AMENDMENT DRAWING

AMENDMENT DRAWING

Project Title: VA PUGET SOUND HEALTH CARE SYSTEM UPGRADE SEATTLE ELECTRICAL DISTRIBUTION FROM 5kV TO 15kV

Drawing Number: 100-EP604T2R

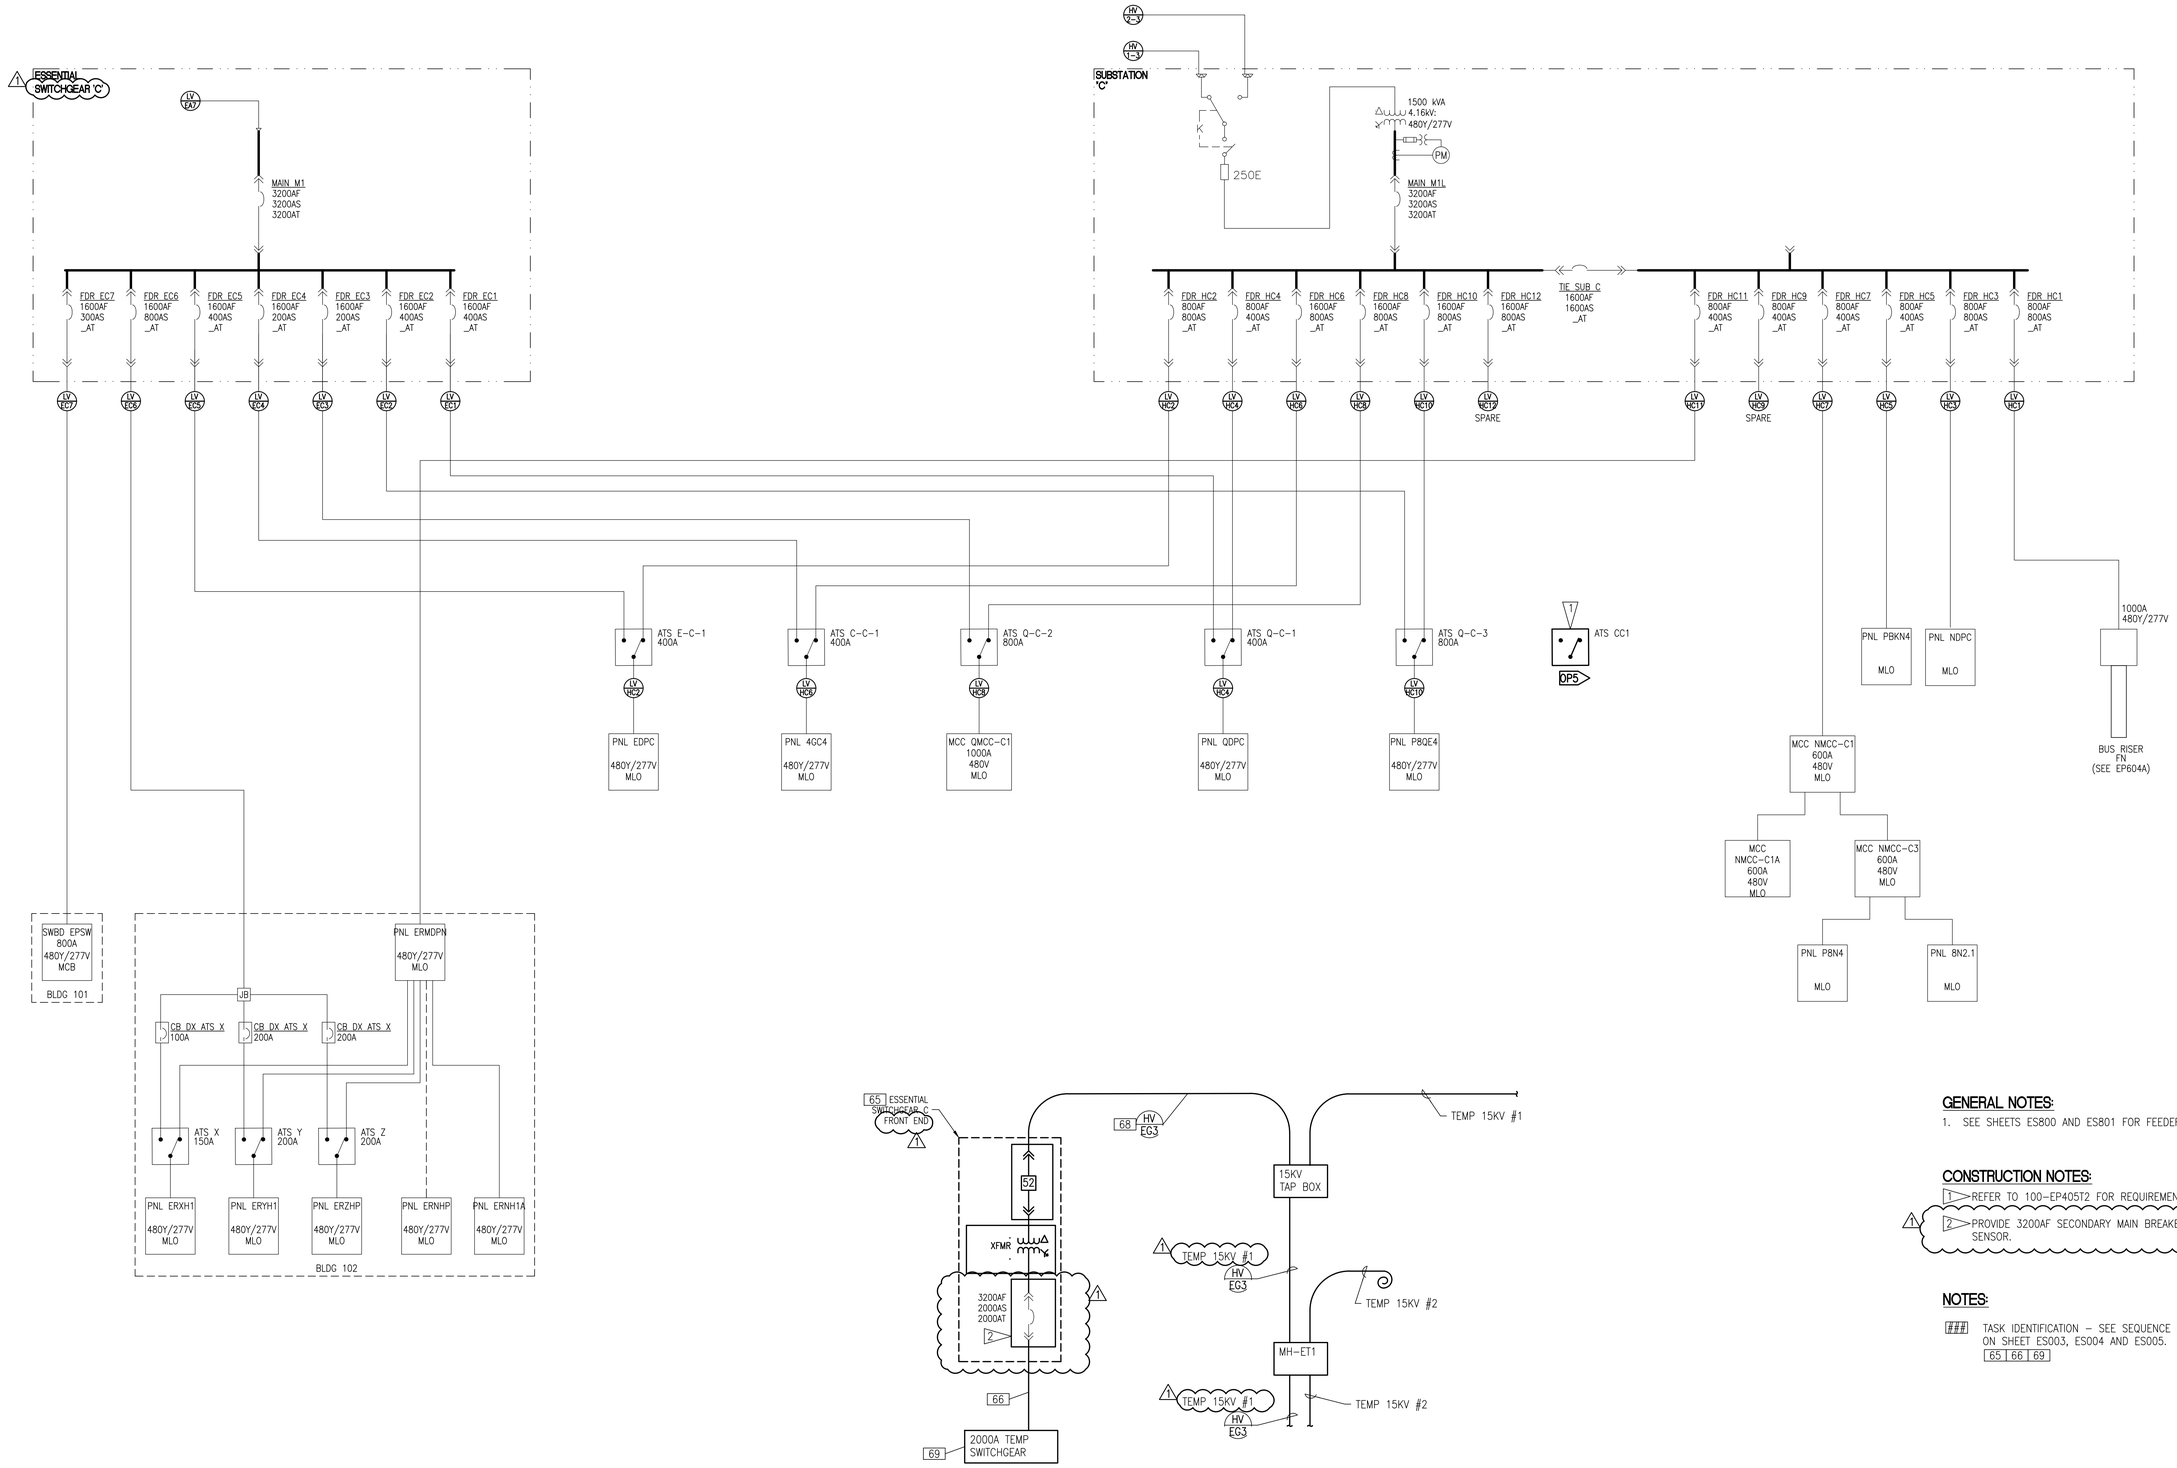
1 REFER TO 100-EP405T2 FOR REQUIREMENT.

1 2 PROVIDE 3200AF SECONDARY MAIN BREAKER WITH 2000AF/2000AT SENSOR.

Drawing Number: 100-EP604T3R

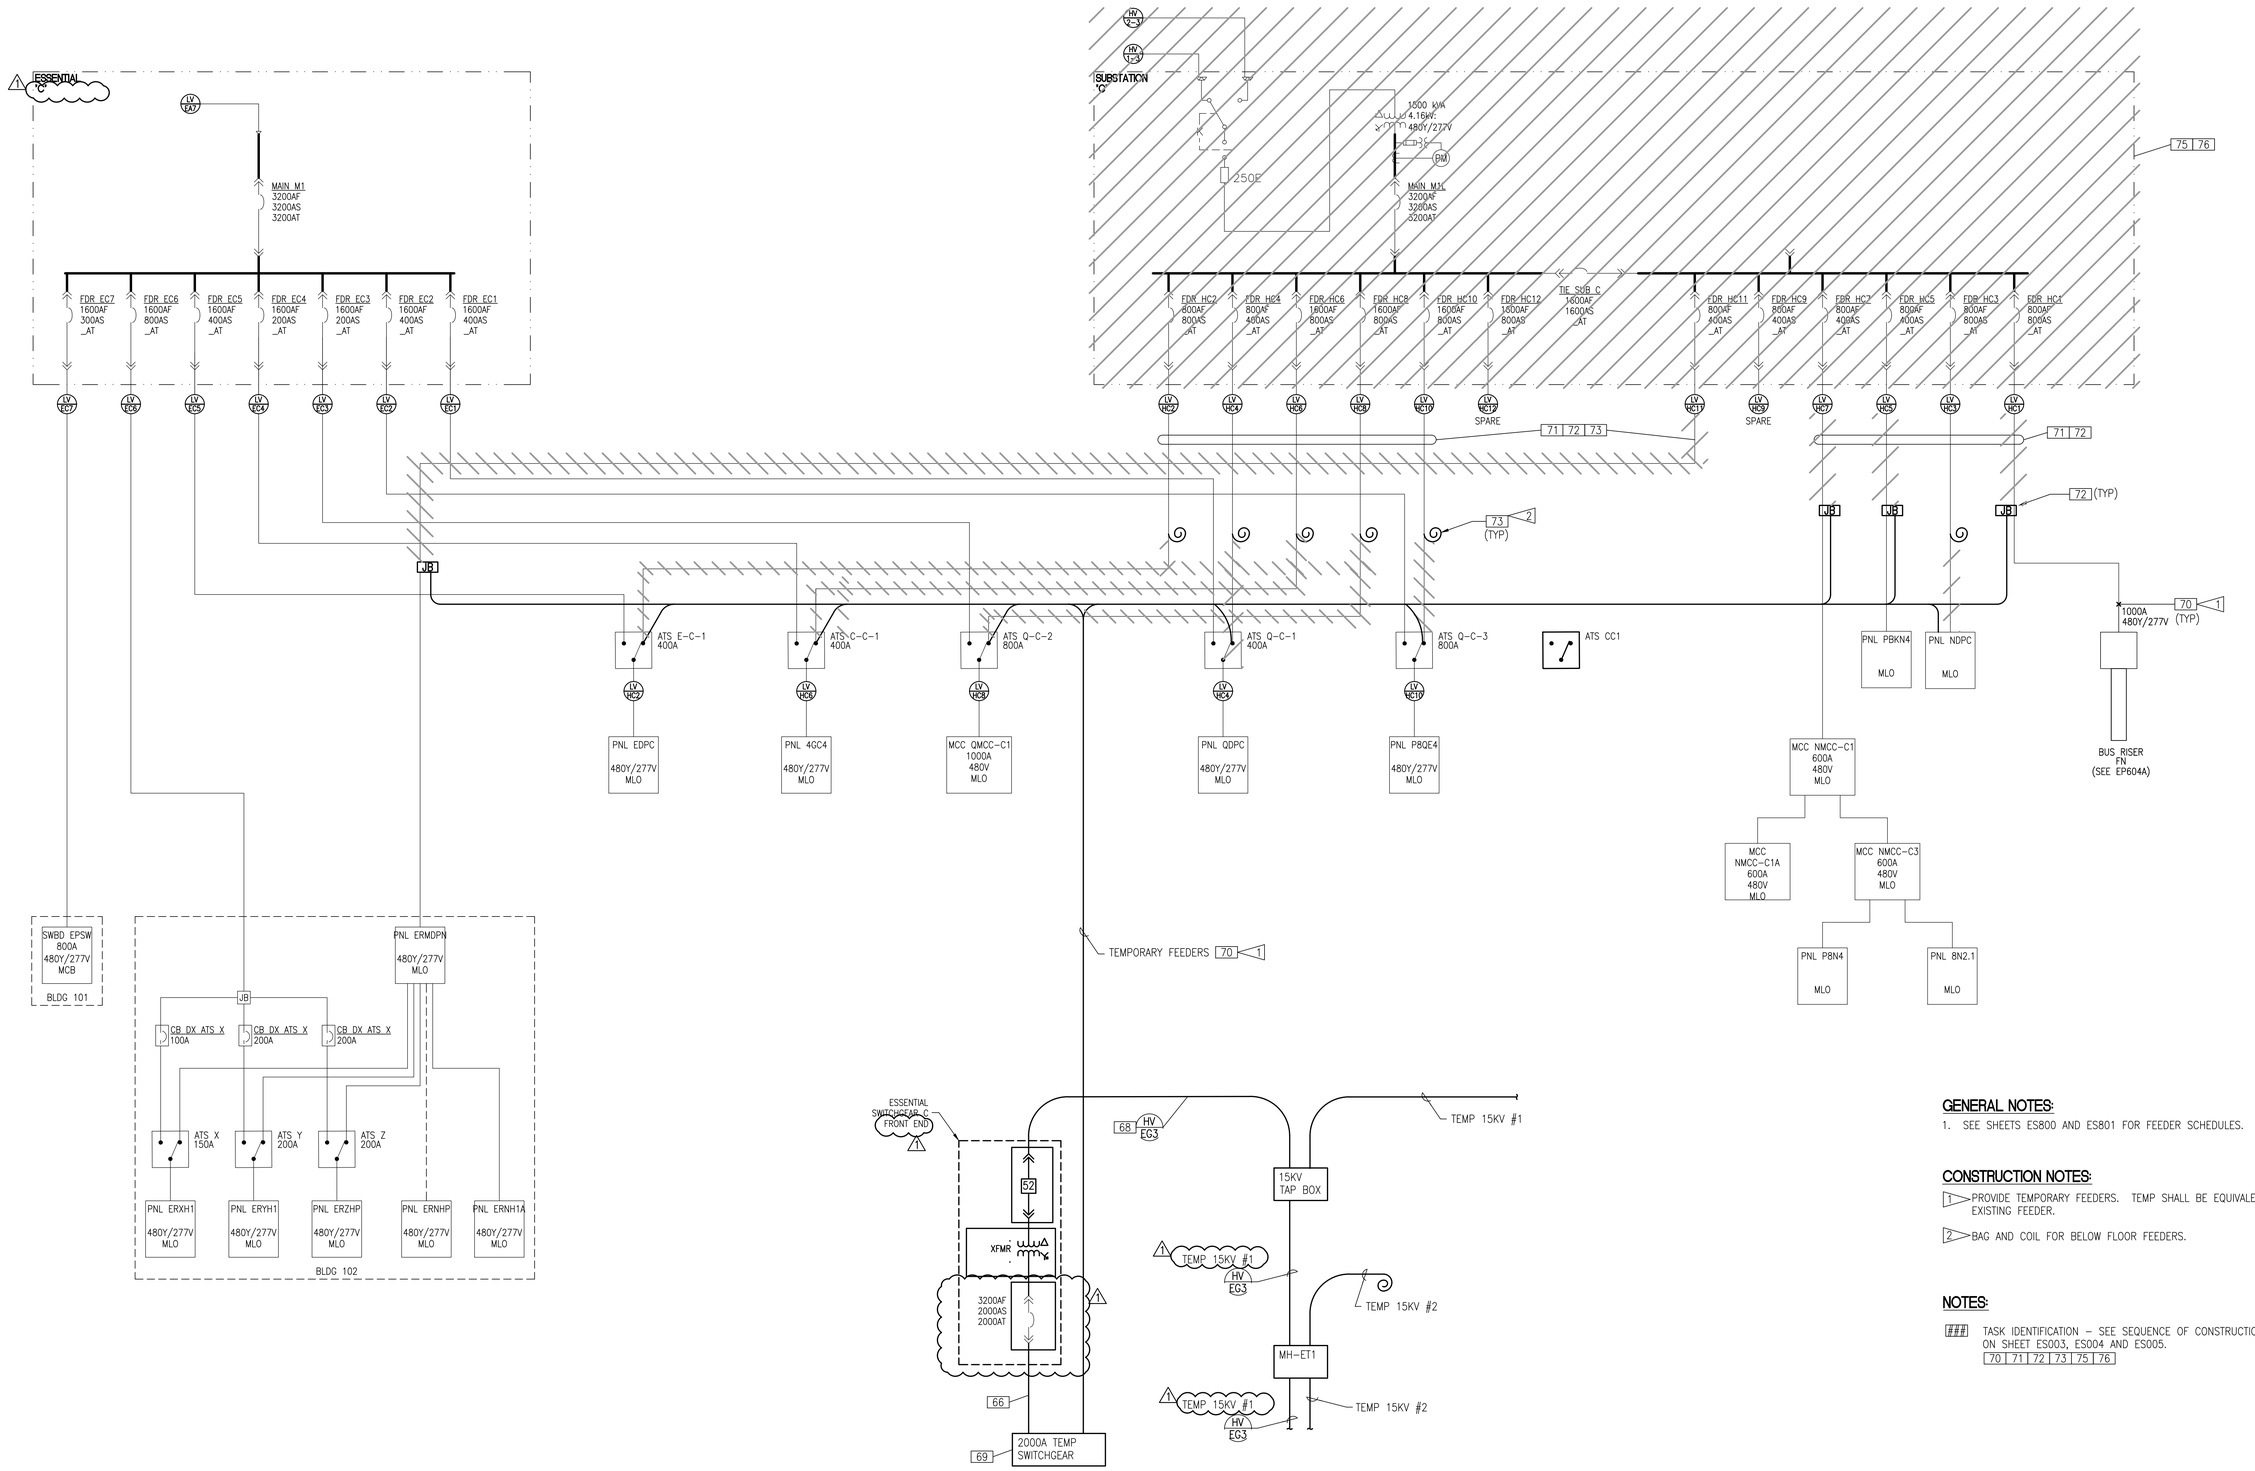
1. PROVIDE TEMPORARY FEEDERS. TEMP SHALL BE EQUIVALENT TO EXISTING FEEDER.
2. BAG AND COIL FOR BELOW FLOOR FEEDERS.

Drawing Number: 100-EP604T4R

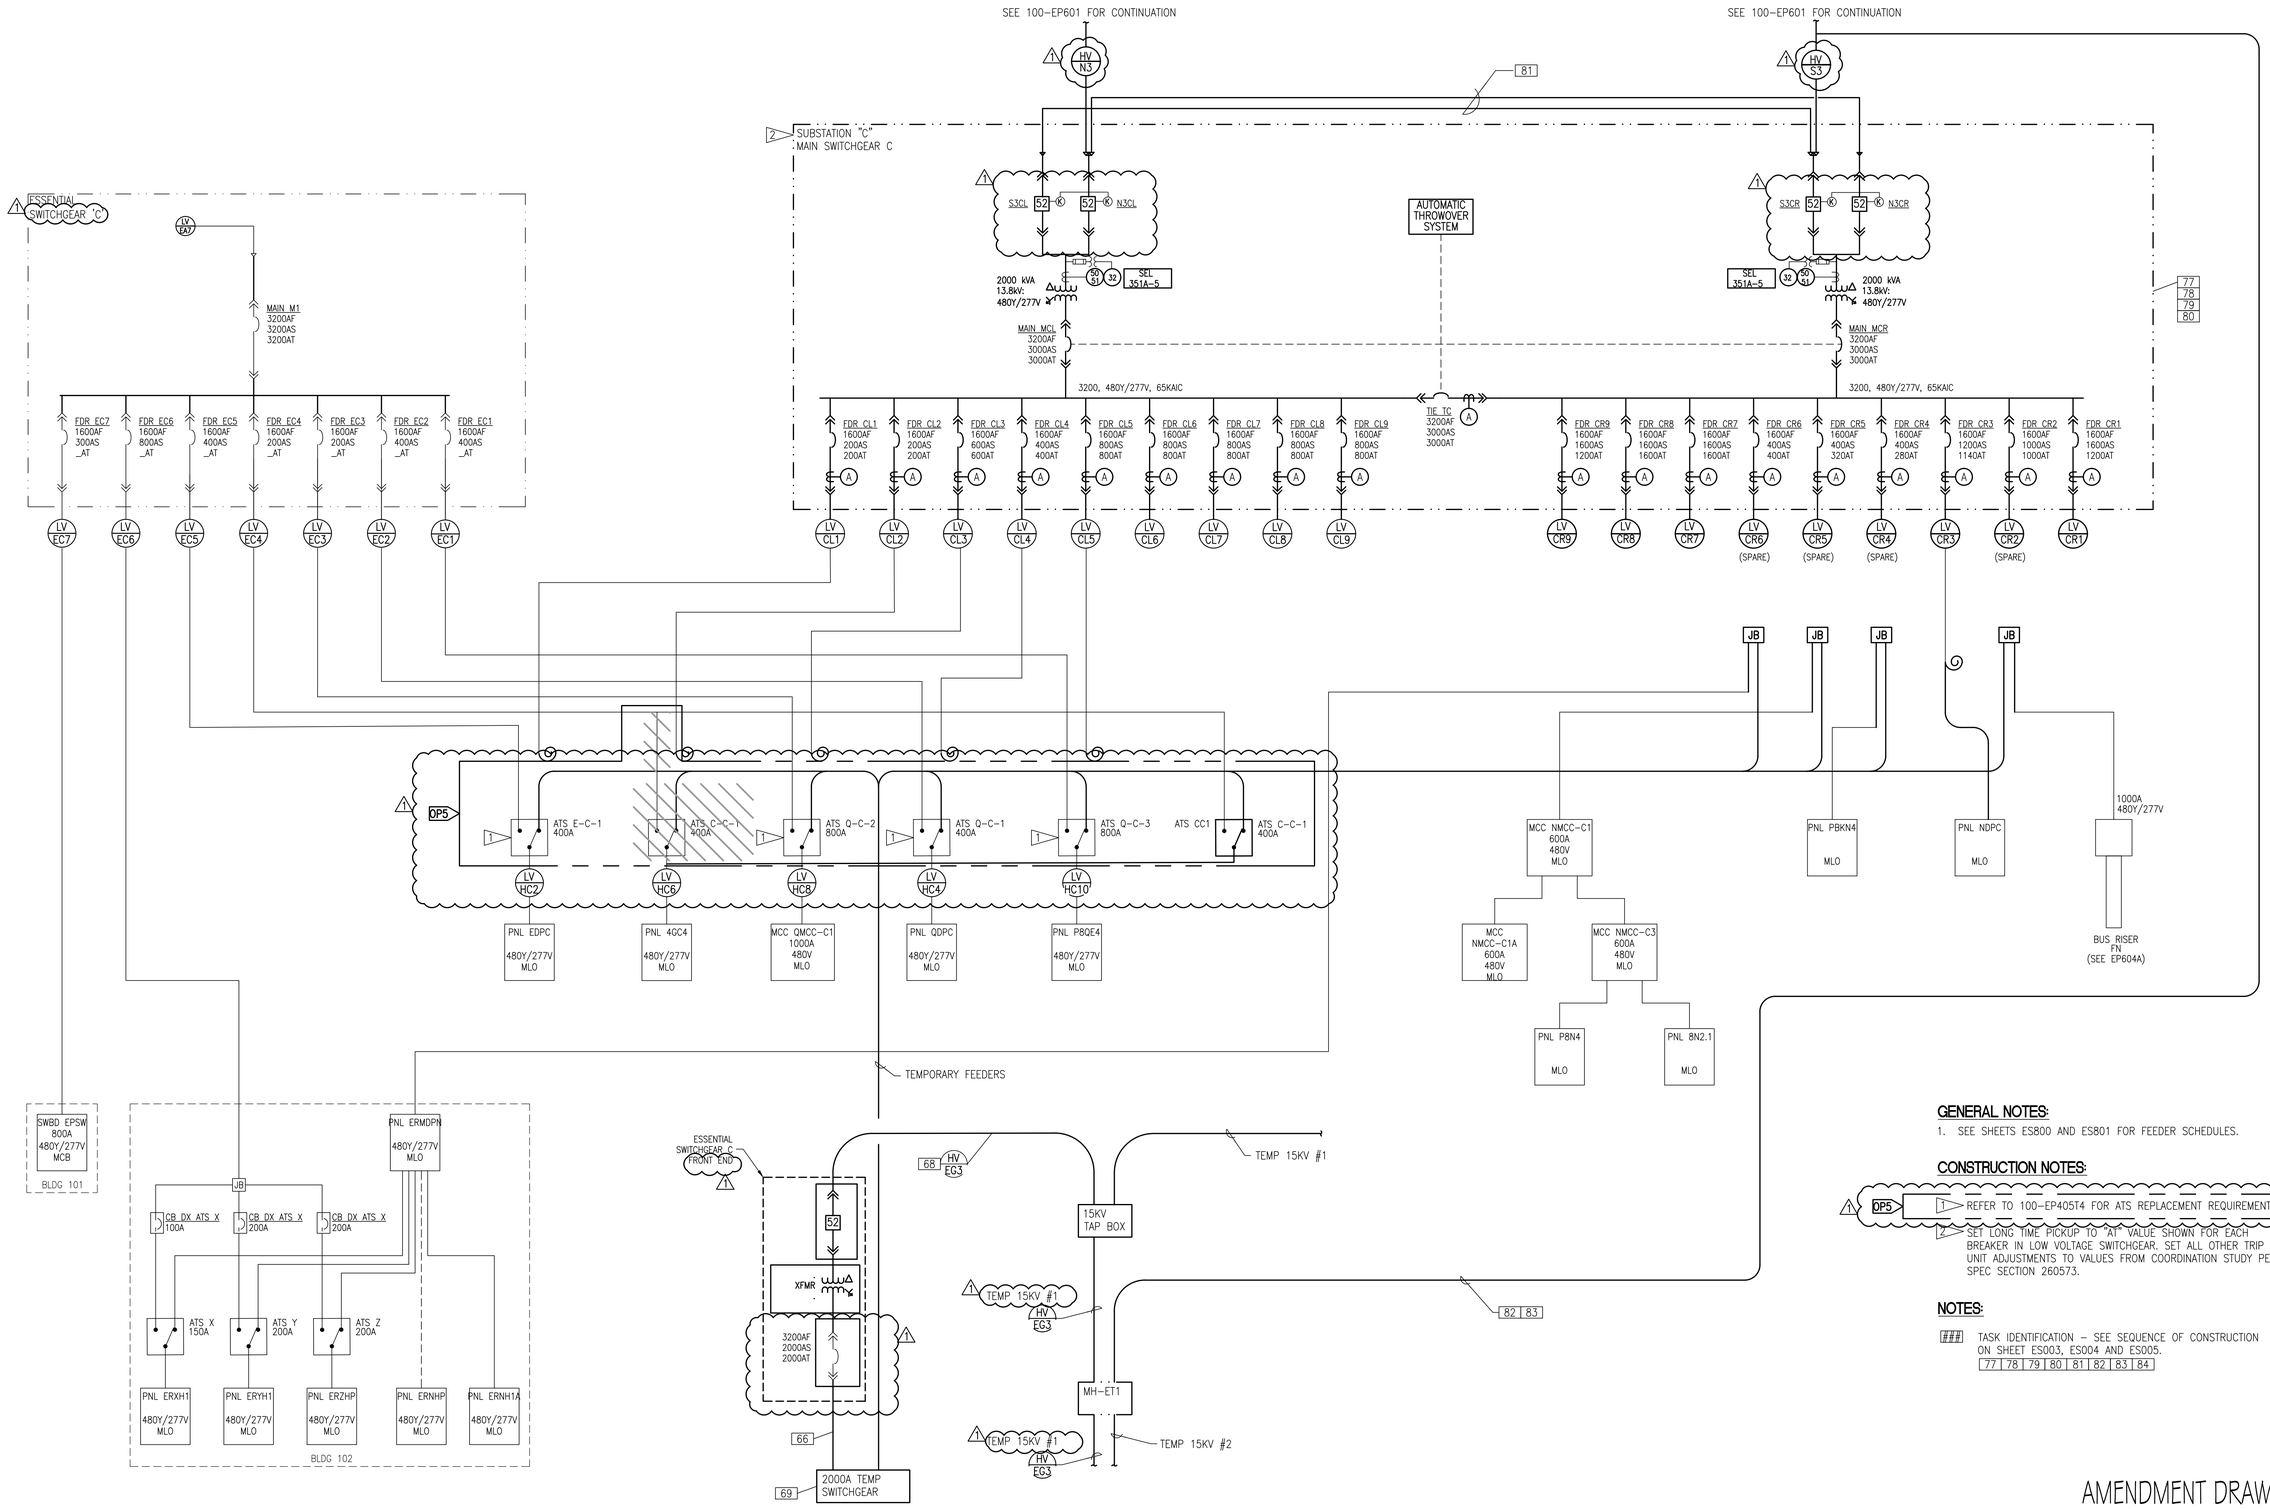
OP5
1. REFER TO 100-EP405T4 FOR ATS REPLACEMENT REQUIREMENT.
2. SET LONG TIME PICKUP TO "AT" VALUE SHOWN FOR EACH BREAKER IN LOW VOLTAGE SWITCHGEAR. SET ALL OTHER TRIP UNIT ADJUSTMENTS TO VALUES FROM COORDINATION STUDY PER SPEC SECTION 260573.
